Refine the Tx/Rx OMA_{outer} for FR4 and FR4-500 (Comments #151-154)

Michael He, Penny Xu, and Rang-Chen (Ryan) Yu

TeraHop

Rx OMAouter Sensitivities Distribution

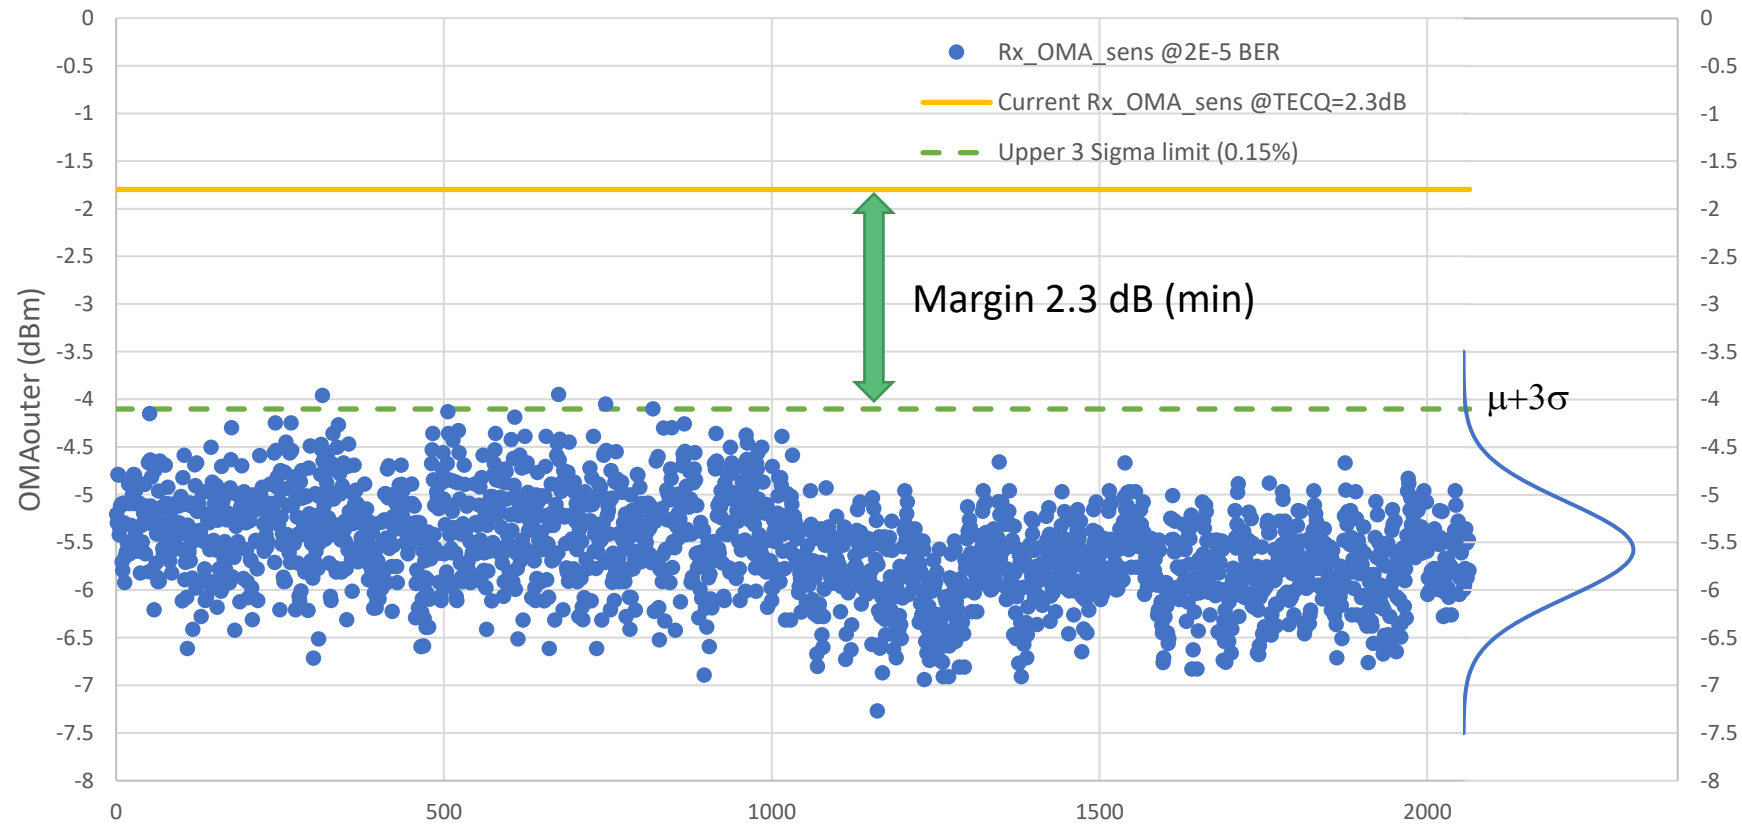
- The Rx DUTs are Sipho based 1.6T 2xFR4-500, the TECQ of the test Tx is in range of **2.3-2.7 dB**
- Rx OMAouter sensitivities were tested **@ pre-FEC BER 2E-5**, which should be adequate for receiver error mask
- The distribution covers more than 2k data samples (86pcs x 8ch x 3-temp) and two main DSP suppliers. The upper 3 sigma limit of normal distribution fitting keeps **~2.3dB** margin from FR4-500 spec @TECQ=2.3dB

Additional margin w/ Inner FEC for FR4

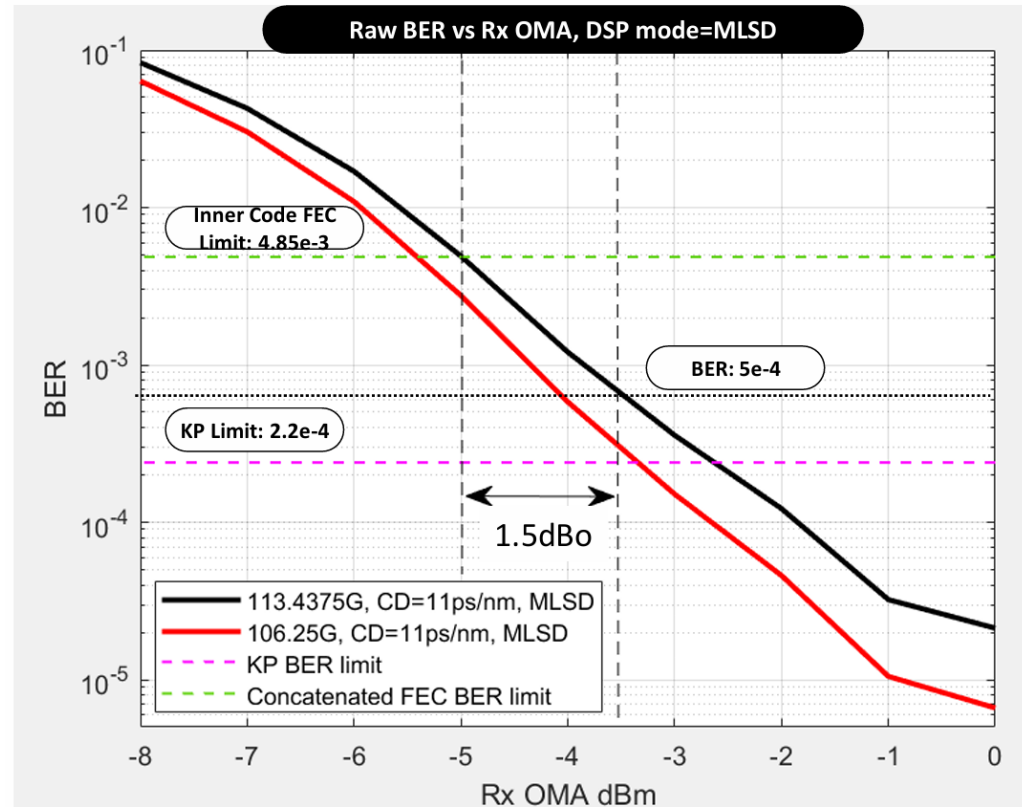
- The simulation results in [parthasarathy_3dj_01_2303](#) show ~1.5dB coding gain with Inner FEC
